This Addendum extends the conclusions and recommendations provided in the Interconnection System Impact Study (“ISIS”) Report dated February 25th, 2005 for MISO project #G376, MISO Queue #37935-03.

This Addendum is required due to the Generator changing from the Vestas V80 2.0 MW machines with AG04 low voltage ride-through in the original Facility Study to a proposed configuration of GE 1.5 MW machines. This Addendum reviews the stability impact of the new wind turbines for only a subset of the faults analyzed in the Facility Study determined to be the worst-case scenarios for the G376 interconnection.

Interconnection System Impact Study Report

**160 MW Wind Generation in
Green Lake/Fond du Lac County, Wisconsin
MISO # G376 (#37935-03)**

Figure E.1 – Customer Provided Fault Ride-Through Characteristics Related to Voltage Tripping of G376 GE Wind Turbines

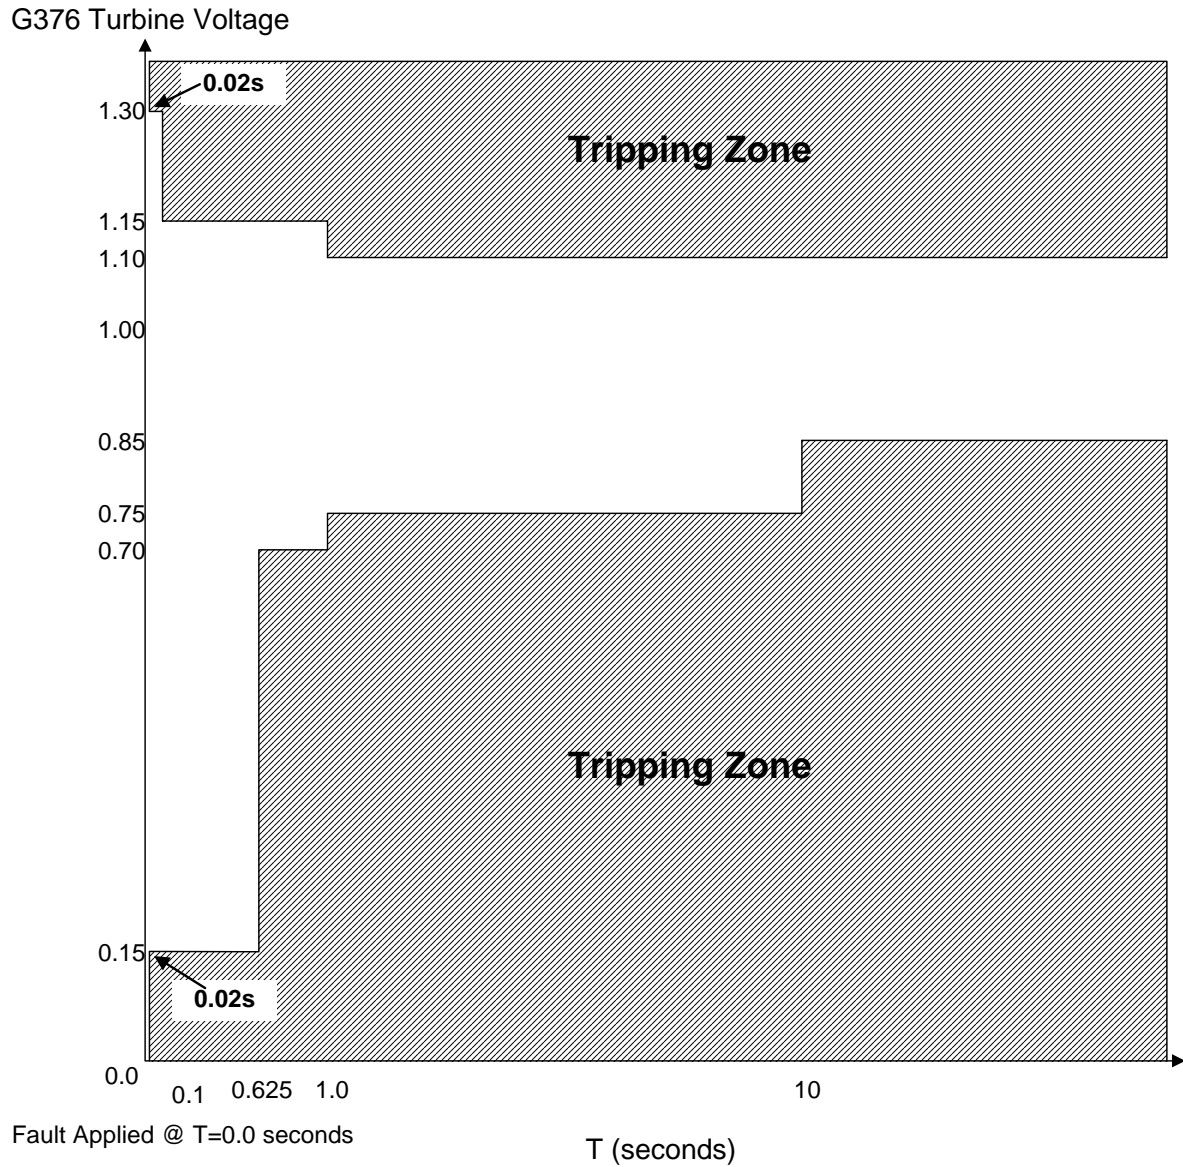
The ISIS required Operation Restrictions on the wind farm due to prior outage stability conditions. With the customer provided low voltage ride through (“LVRT”) the performance of the proposed GE induction machines is better than the original Vestas units. The Stability Operation Restrictions identified in the ISIS will no longer be required. Table A.3 shows the changes in system and machine performance for the studied faults. The wind farm will require the proposed LVRT shown in figure E.1.

Therefore, based on the model supplied by the Generator for this restudy, the proposed configuration change is acceptable.
